CITY OF KIRKLAND

ADVISORY REPORT FINDINGS, CONCLUSIONS, AND RECOMMENDATIONS

File: _____ Pier and Shoreline Enhancement

1. Applicant:
2. Site Location:
3. Request: Remove an existing solid cement breakwater and install a 467 square foot new fully grated pier, native plantings, together with shoreline habitat enhancement features. There is an existing shed and deteriorated boat rail system. The boat rails will be removed, but the shed will remain (see Attachment 2).
4. Review Process: Process I, Planning Director decision. The Kirkland Zoning Code (KZC) Chapter 83 sets forth the circumstances under which a Substantial Development Permit (SDP) is required. KZC section 83.170 indicates that within the RL Shoreline Designation, new piers require an SDP.

SITE PLAN - NEW PIER AND SHORELINE HABITAT ENHANCEMENT PLAN

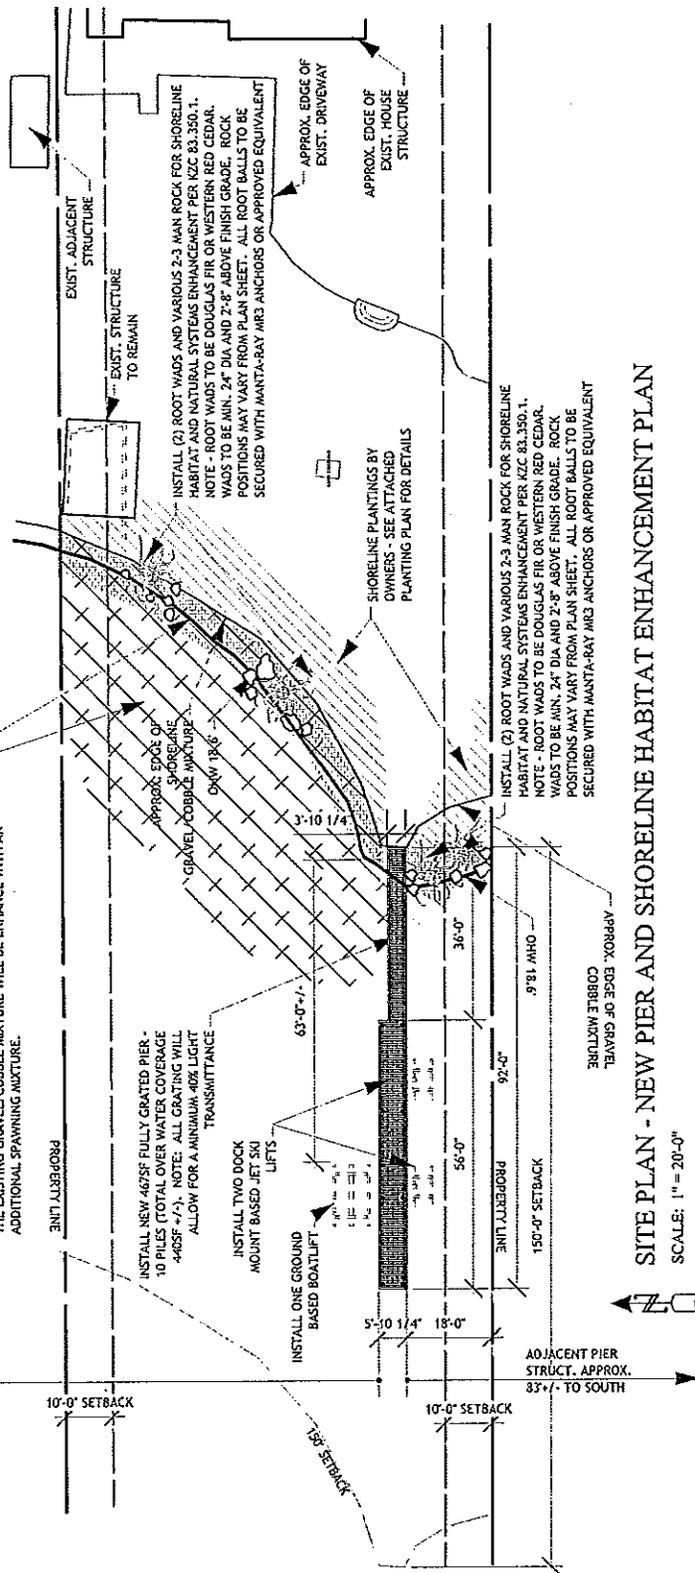
long		fingers and attached floats	that they will not have an adverse impact on navigation
	X* Plans show the pier is 3'10" wide for first 37', then 5'10" for 56'	Maximum Width	4 ft. for pier or dock walkway or ramp For piers or docks with no ells or fingers, the most waterward 26 ft. section of the walkway may be 6 ft. wide <u>*Pier modifications:</u> The City shall approve modifications to a new pier proposal that deviates from the dimensional standards of KZC 83.270.4, subject to both US Army Corps of Engineers and Washington Department of Fish and Wildlife approval to an alternate project design.
X Pier shown as 1.5' from OHWM to stringers		Height of piers and diving boards	Minimum of 1.5 ft. above ordinary high water to bottom of pier stringers, except the floating section of a dock and float decking attached to a pier
X Plans indicate compliance		Decking for piers, docks walkways, platform lifts, ells and fingers	Piers, docks, and platform lifts must be fully grated or contain other materials that allow a minimum of 40% light transmittance through the material

The applicant's plans show that all native riparian vegetation will be planted in 75 percent of the nearshore riparian area at a 10 foot depth except where the pier walkway meets the shore, where the plantings taper down to a 5 foot width. Additionally, there is an existing shed within the nearshore area that will remain. Plantings will be placed in front of it, but a 10 foot depth cannot be attained where the shed sits.

The applicant's plans show that native vegetation plantings comply with the mitigation requirements with the exception of the number of trees. The applicant has roughly 119 lineal feet of shoreline, and is proposing only 2 trees. One additional tree should be planted.

- 2. Conclusion: The applicant's plans indicate that the new pier complies with setbacks, and dimensional and design standards with the exception of the width of pier and the need for an additional tree. The following conditions should be met for compliance with Chapter 83:

2. As part of the building permit submittal:
 - a. Show on the planting plan, one additional tree together with the two proposed trees; show that the root wads are placed in the water far enough so that they can provide adequate habitat for fish, but not far enough to be a hazard to watercraft (See Conclusions II.E.2.a and II.F.2).

- b. Provide documentation that the US Army Corp of Engineers and the Washington Department of Fish and Wildlife have approved the alternative proposal to have

the pier be 6 feet in width for the most waterward section that is 56' long (see Conclusion II.E.2.b).

- a. One additional tree should be added to the planting plan that was submitted for this proposal.
- b. The applicant should provide documentation that the US Army Corp of Engineers and the Washington Department of Fish and Wildlife have approved the alternative proposal to have the pier be 6 feet in width for the waterward section that is 56' long.

SIDE MOUNT JET SKI LIFT DETAIL - D

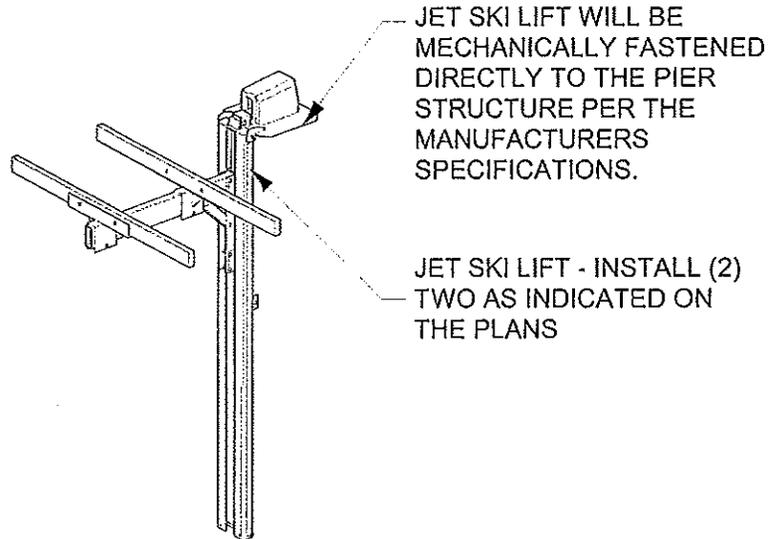
A building permit is required for the construction of the proposed pier. Provide structural calculations that account for the loads due to the side mounted jet ski lifts.
